Central Planning Authority

Agenda for a meeting of the Central Planning Authority to be held on **August 30, 2023 at 10:00am** in Conference Room 1038, 1st Floor, Government Administration Building, and Elgin Avenue

CPA/19/23

Letter #1

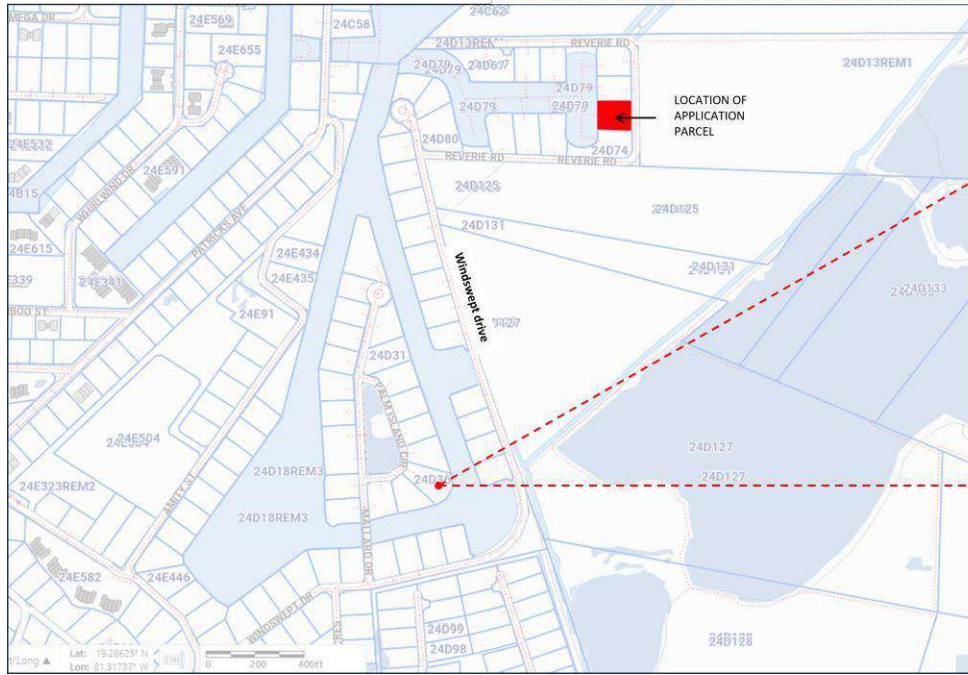
This letter is to apply for a variance setback for the cabana. This will improve connection to the dock extension

Letter #2

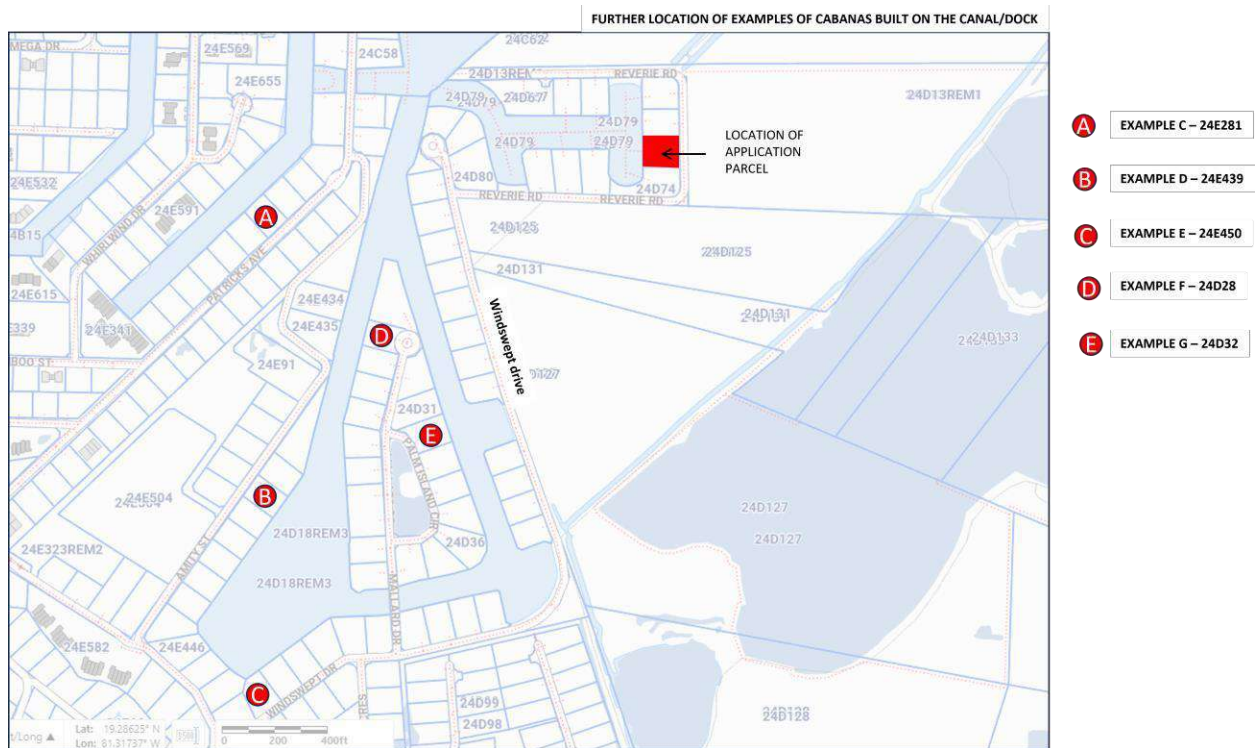
This letter is to apply for a variance setback for the cabana. This will improve connection to the dock extension. There are various other built examples of this request in the neighboring parcels. See below for reference.
